- 4      22 HENRY ST, RYDE. Lot 2 DP 602362. Development Application for subdivision of the site (Cudal Reserve) into two lots. Lot 21 is proposed to be dedicated to Council for use as open space. Lot 22 will be used for 'residential purposes'. LDA2010/0078.**

**Report prepared by:** Senior Town Planner

**Report dated:** 2/08/2010

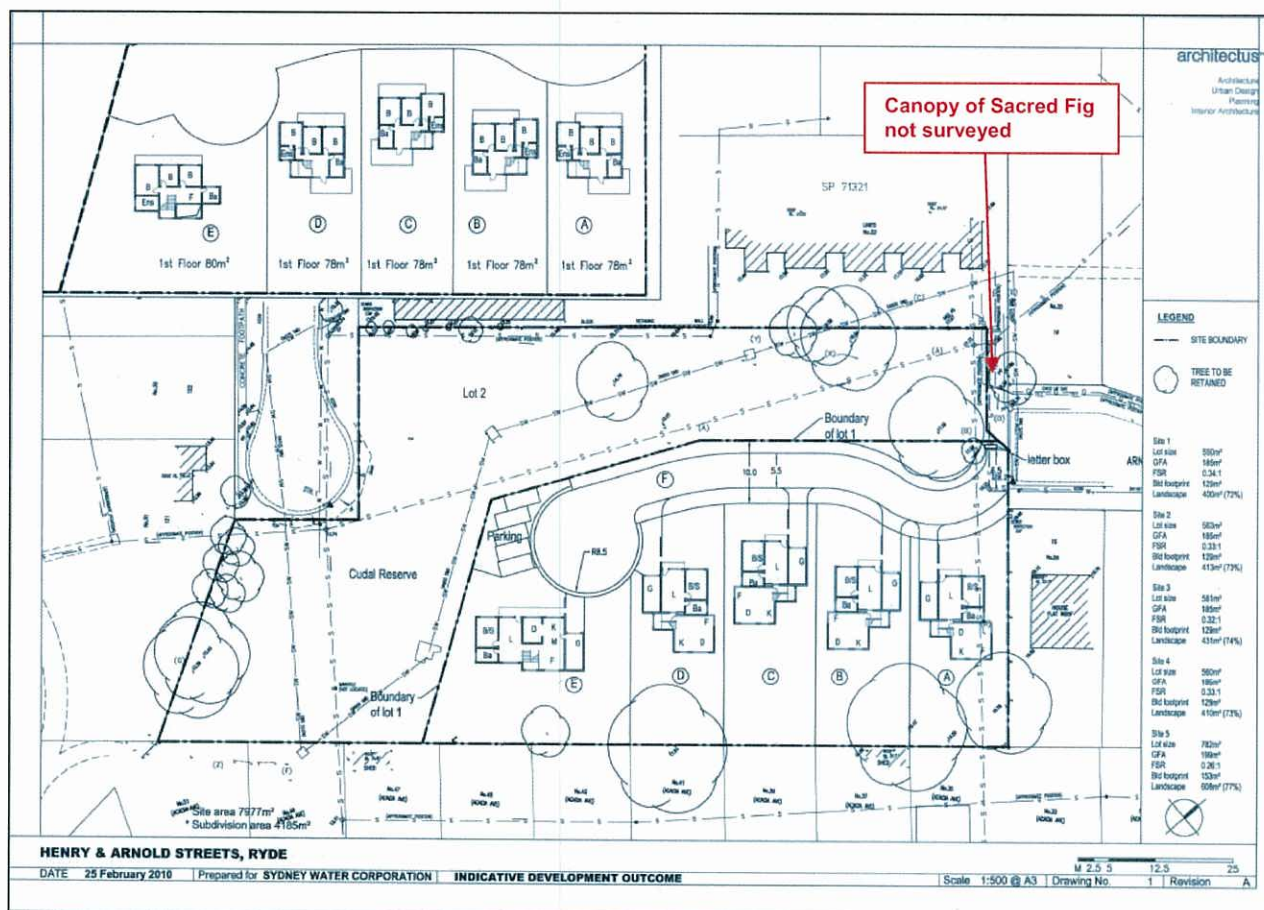
On 21 June 2010, Council received amended plans showing the dedication of Lot 21 to Council and a right-of-way of variable width extending around the Sacred Fig and which permits access from Arnold Street over Lot 22 on to Lot 21 (see previous plan of subdivision in section 5 of this report).

An on-site meeting was subsequently held on 17<sup>th</sup> May and was attended by Council's Development Engineer, Consulting Landscape Architect and senior planning staff. It was determined at this meeting that the proposed line of subdivision submitted with the DA shows that line within close proximity of the Sacred Fig wherein the trunk of the tree falls within Lot 21 (to be dedicated to Council) and the remaining majority of canopy and tree root zone will be shared between Lots 21 and 22.

It was determined on-site that adequate space exists at the access point to the site from Arnold Street that could permit a minor amendment to the line of subdivision in which the majority of the Sacred Fig could be relocated within the Council dedicated allotment and still provide sufficient vehicular access to Lot 22 and therefore limit the extent of roots which would be affected by a future driveway to Lot 22.

1. This consent shall not operate until the applicant has submitted to Council an amended plan of subdivision that shows the following:
  - (a) **Protection of Sacred Fig:** The plan of subdivision shall be amended so that the line of subdivision between the proposed lots diverts around the canopy of the Sacred Fig tree so that the tree falls within Lot 21. In this regard a detailed survey plan shall be prepared and submitted to Council that shows the location of the tree, its existing canopy and the amended line of subdivision.
  - (b) **Right-of-way:** The right-of-way upon Lot 22 shall be maintained to ensure unencumbered pedestrian access from Arnold Street onto Lot 21 (being the area to be dedicated to Council).
  - (c) **Dedication of Lot 21:** The plan of subdivision shall retain the dedication of Lot 21 to Council; and

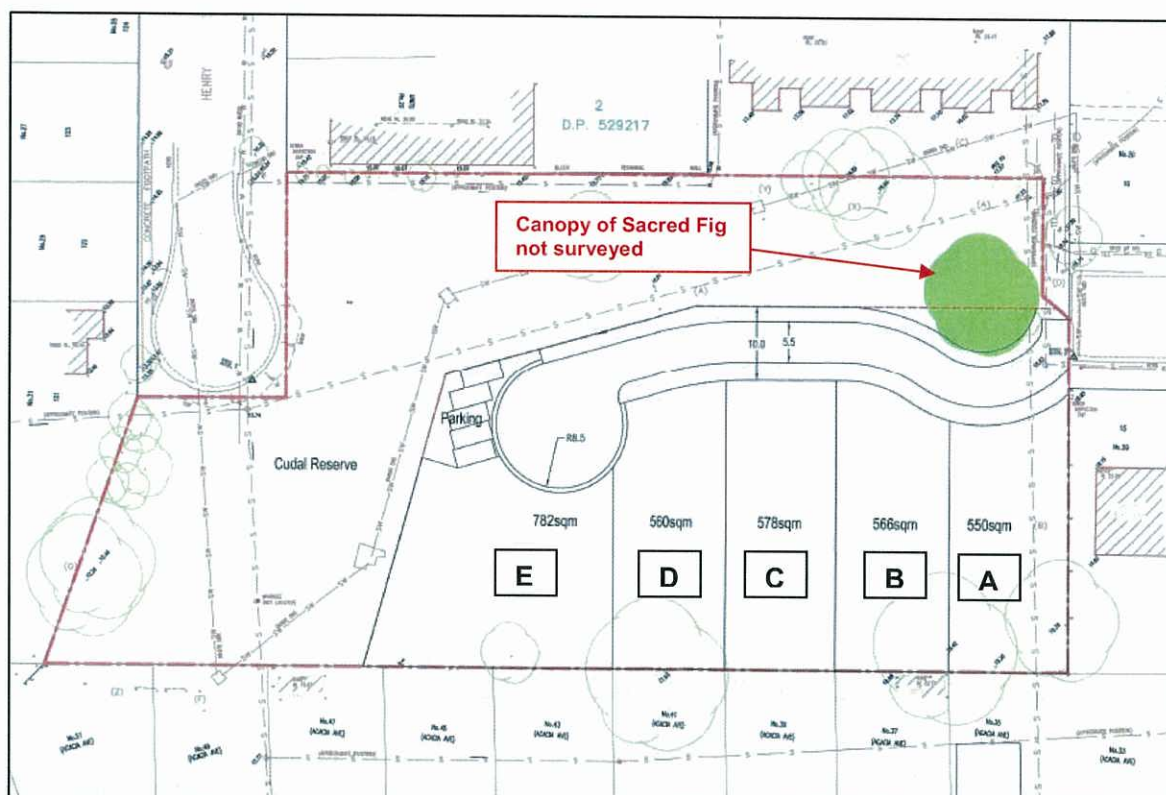
In addition to the 2 lot subdivision, the applicant has submitted an 'indicative development outcome' which illustrates the future potential subdivision of Lot 22 into 5 allotments. As previously stated, this plan is indicative only and development consent is not sought for this layout. The following diagram demonstrates this layout plan.

The response to these objectives is based on the 'Indicative Development Outcome' plan which proposes 5 single residential allotments on Lot 22.

The proposed 5 lot subdivision would be consistent with the established subdivision pattern in the locality. The proposed allotments of land will be adequate enough to provide for minimum site requirements and will provide adequate aspect and outlook for future buildings on those allotments.
